PLANNING COMMISSION STAFF REPORT

24 and 9 Planned Development & Minor Subdivision Petitions PLNSUB2012-00503 and 00504 2442 South 900 East October 24, 2012

Department Comments
2442 S 900 East Street
PLNSUB2012-00503 Planned Development
PLNSUB2012-00504 Subdivision Amendment

Site Plan

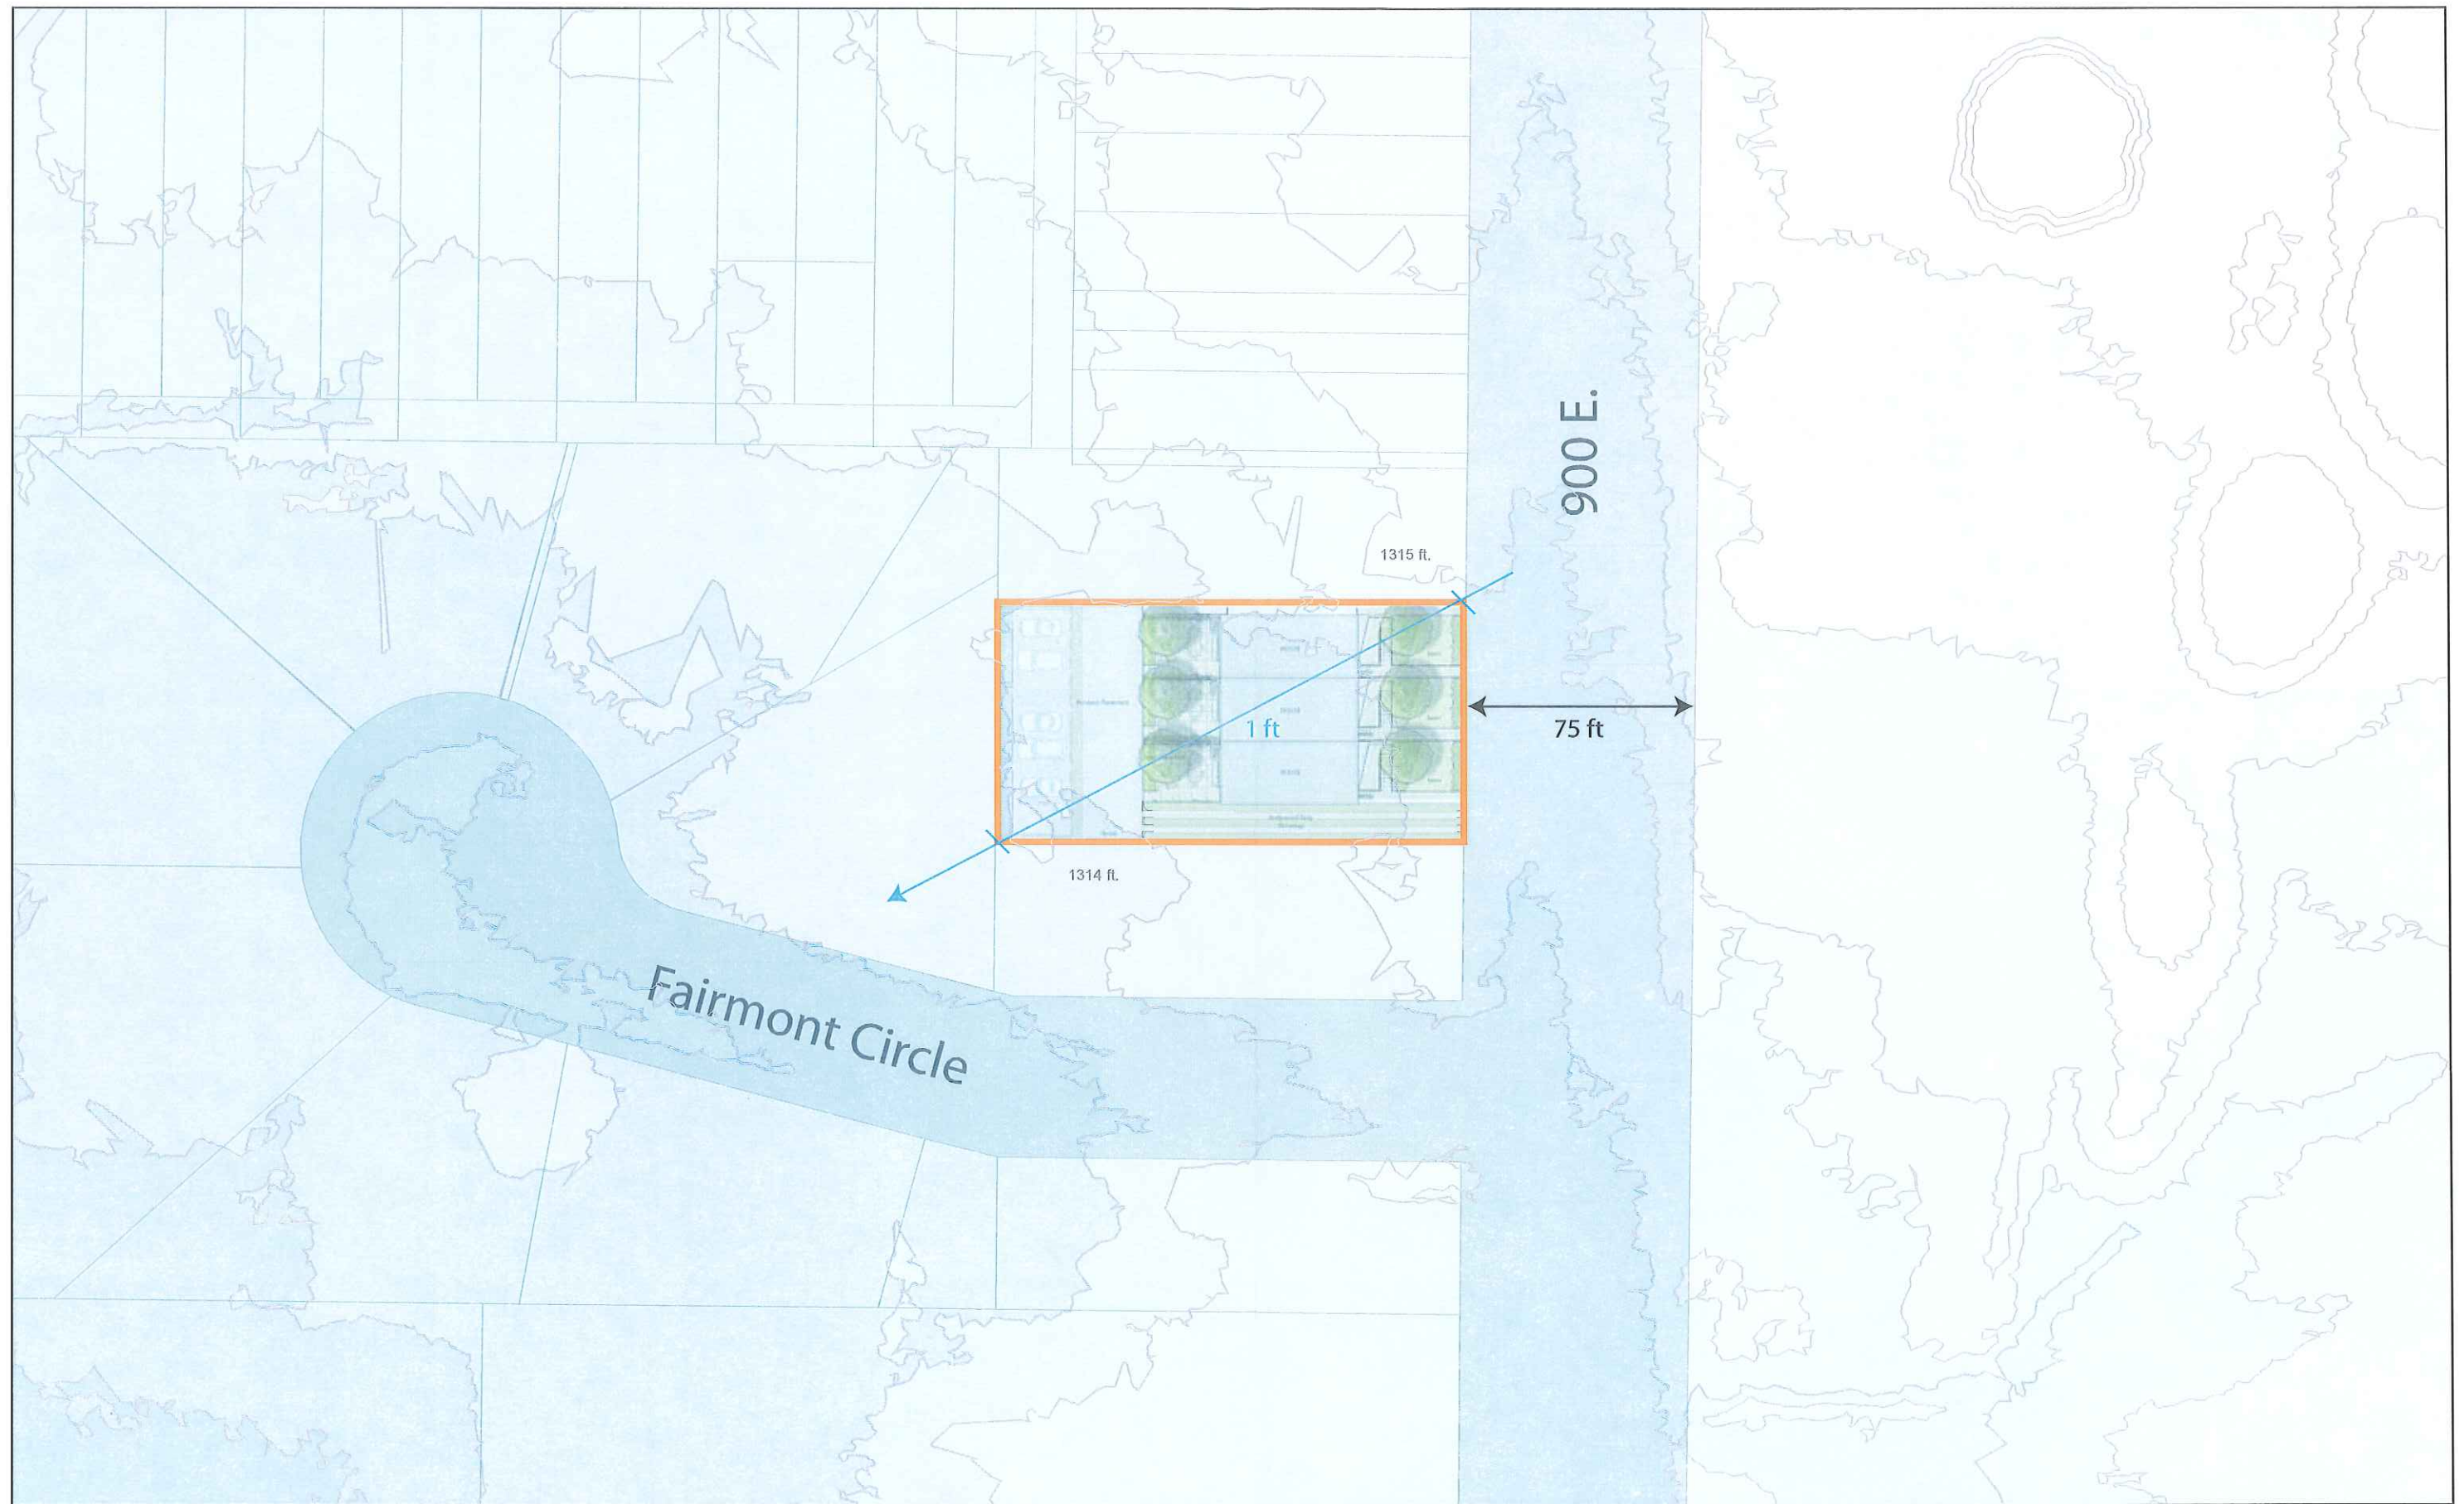
However, the proposed accessory structure on Lot 4, which is a covered parking and storage structure for all three dwelling units, constitutes an "accessory use on an accessory lot"—which is not allowed within the RMF-30 District and cannot be remedied by planned development approval since modification of the land use table is beyond the authority of the Planning Commission. To resolve this issue, the applicant must amend the development plan to include the accessory structure(s) on Lots 1, 2, and 3, and restrict Lot 4 to ingress and egress purposes only. This modification of the development proposal will increase the lot area of Lots 1, 2, and 3, which will improve the level of regulatory compliance, not diminish it. As such, staff recommends approval upon condition that this issue be resolved before final planned development and subdivision approval is granted.

8/31/2012	Zoning Review	Complete	Butcher, Larry	Preliminary subdivision plat and site plan do not match. Lots do not meet minimum lot width or lot area in RMF-30. Overall parcel does not provide 3,000 sq ft per unit. Unable to determine building height from submitted plans. Two parking stalls required per unit. Site plan indicates carports, plat indicates garages.
9/5/2012	Public Utility Review	Complete	Maloy, Michael	I have reviewed the proposal for the Forest Dale subdivision, a proposed Planned Unit Development. Representing the Public Utilities Department, and offer the following comments: Parcel A is labeled as a "Private Ingress and Egress & Public Utility and Drainage Easement." After reviewing our maps and speaking with the surveyor that prepared the plat, we conclude that there appears to be no need for a Public Utility and Drainage Easement on the property.

7. Applicant shall amend site plan and subdivision plat to include accessory structures on Lots 1, 2, and 3.

**24 and 9
PRELIMINARY
PLAT**

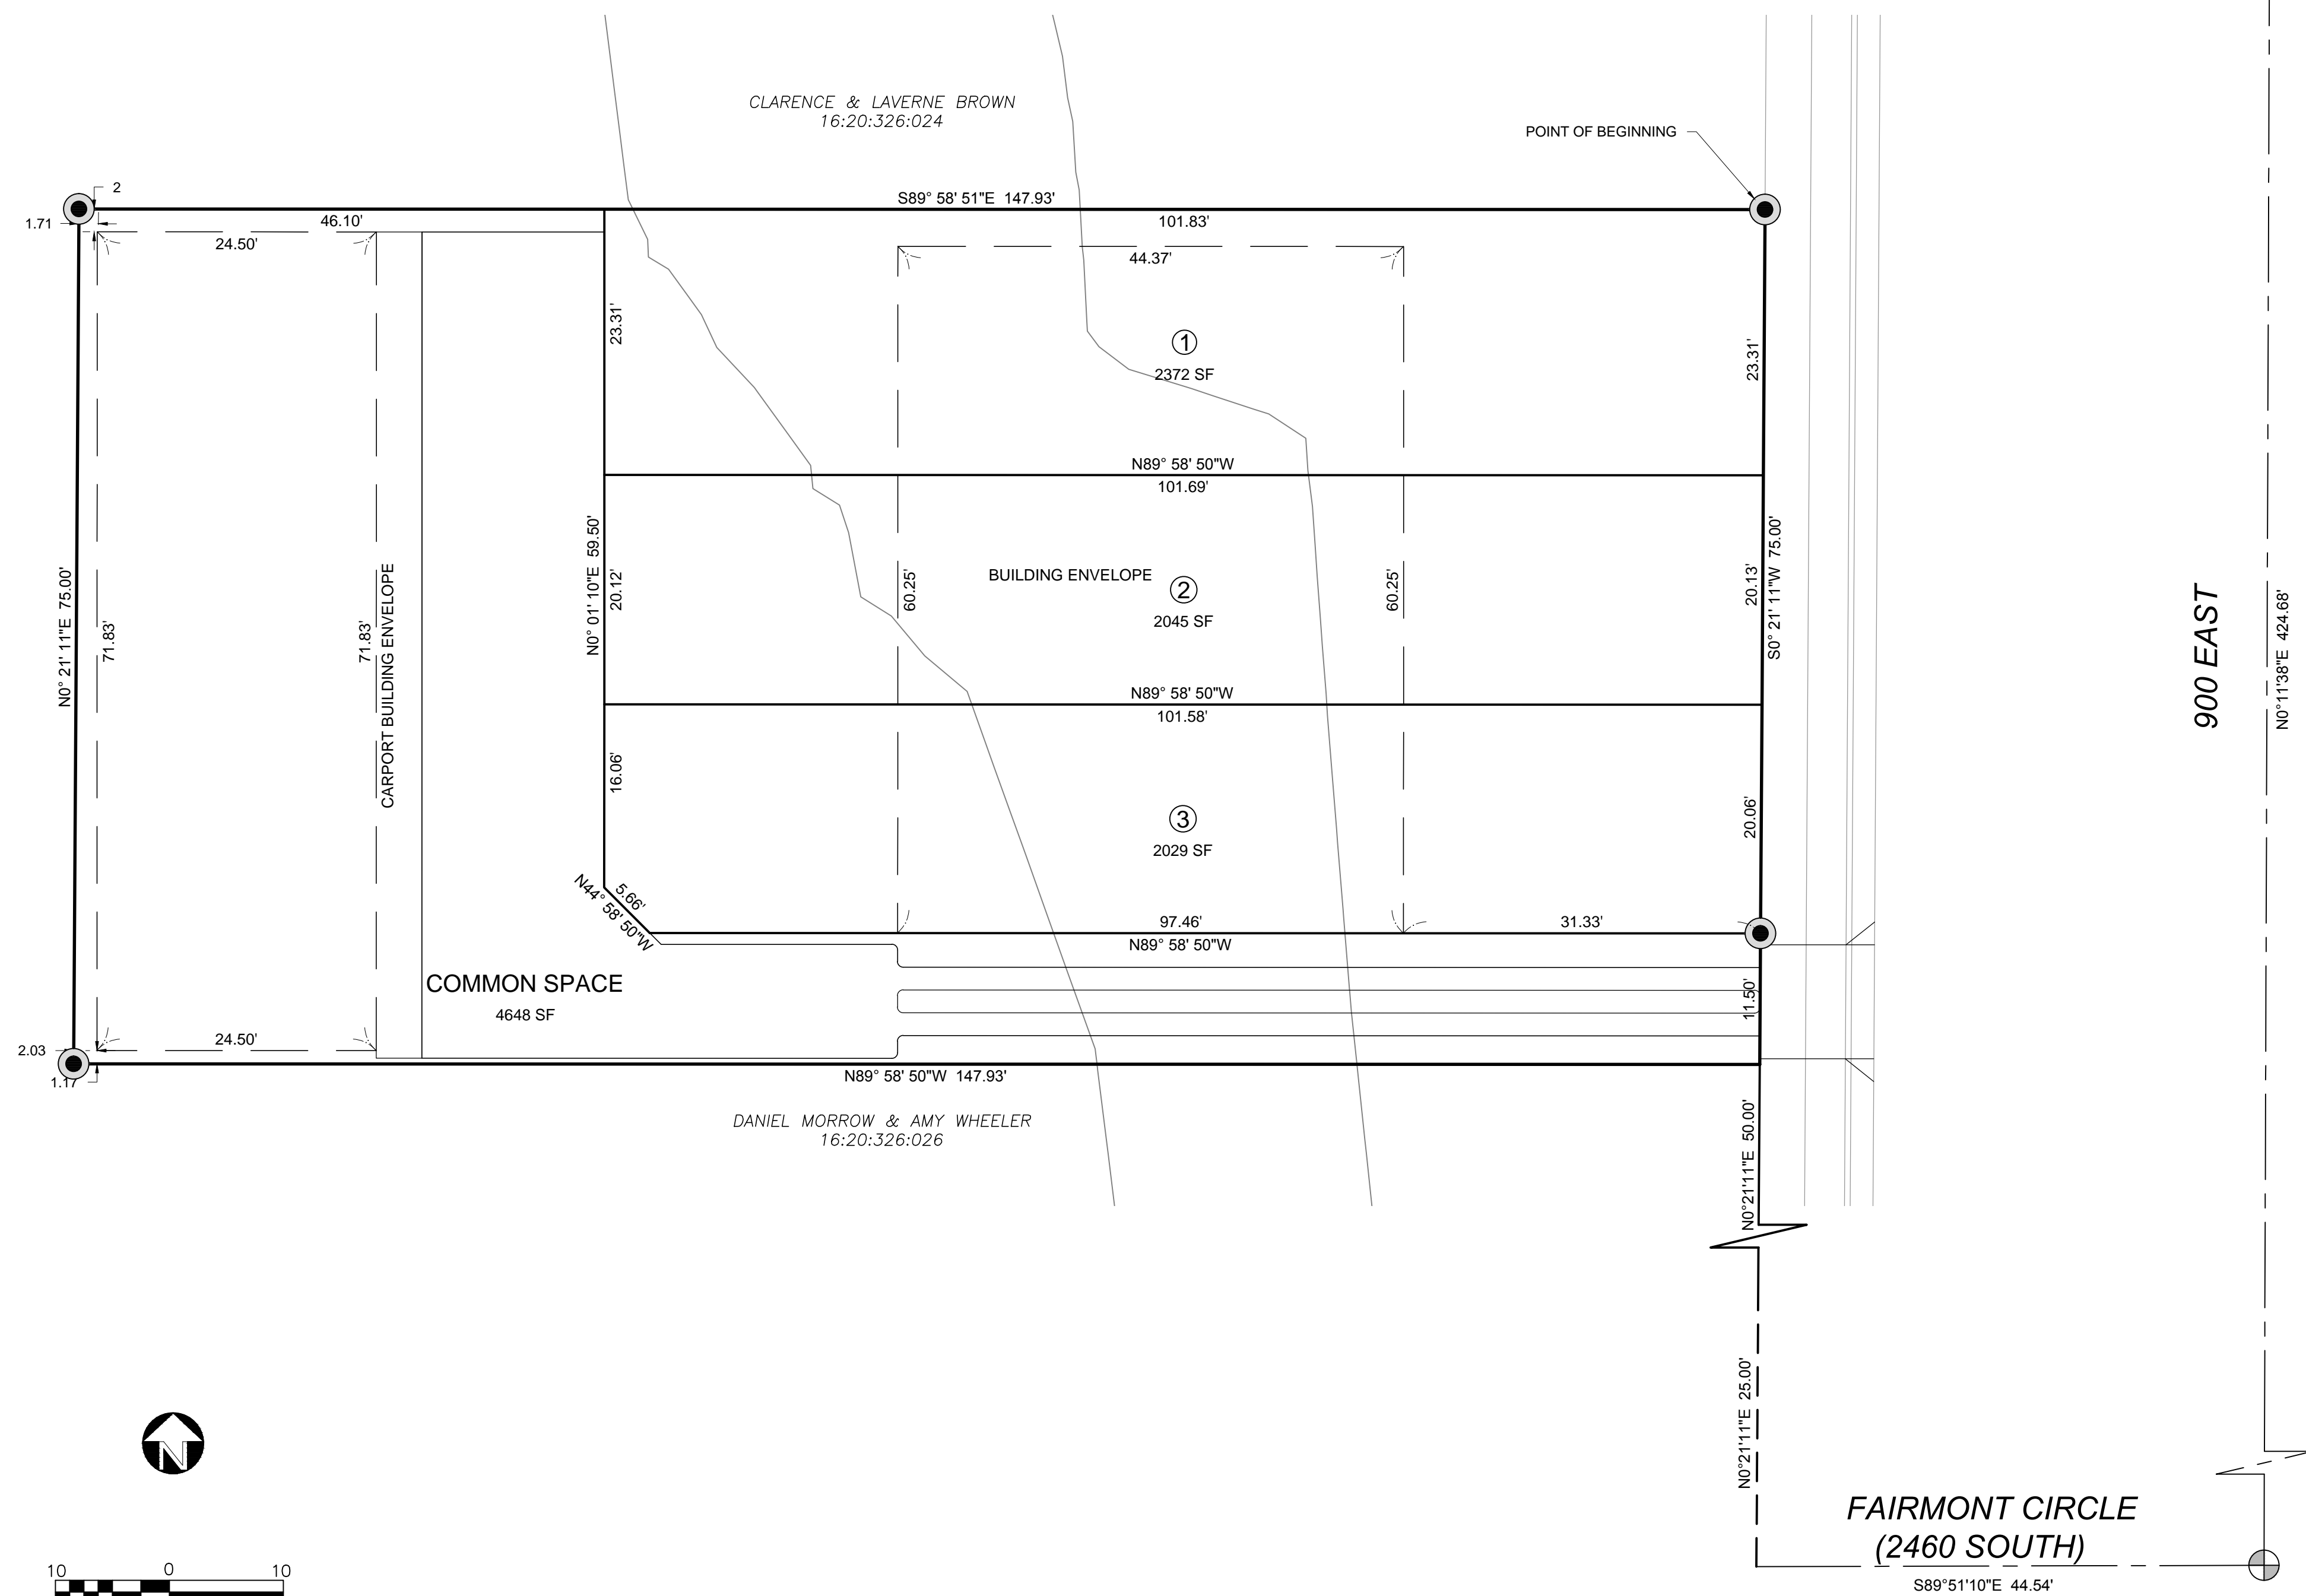
<p>If the PUD proposes to divide the lot into "limited common" spaces then private utility and private drainage easements, which are privately maintained would need to be identified and referenced on the plat.</p> <p>Public Utilities will provide one culinary water service and one sanitary sewer service to the parcel. As part of the permitting process, the civil engineer improvement plans should propose only one water and sewer service. The separate users in the PUD would connect to the singular service. Privately owned sub-meters may be located on private property for sub-metering the water service for private use, however an individual entity will need to be prepared to receive the master utility bill for water and sewer services. The plat should be revised to accommodate the need for potential private utility easements in areas where private utility services may be located in areas that are not considered common space. The same would apply for drainage easements.</p> <p>Proper easements are best defined by meets and bounds by separate document and recorded with the County Recorder's Office. The boundary of the easement along with, identification, and reference to the recorded document are then shown on the plat. Easements recorded by plat are problematic.</p> <p>The proposed preliminary plat shall be revised to correct references to "South Salt Lake City."</p> <p>Justin D. Stoker, PE, LEED® AP, CFM</p>
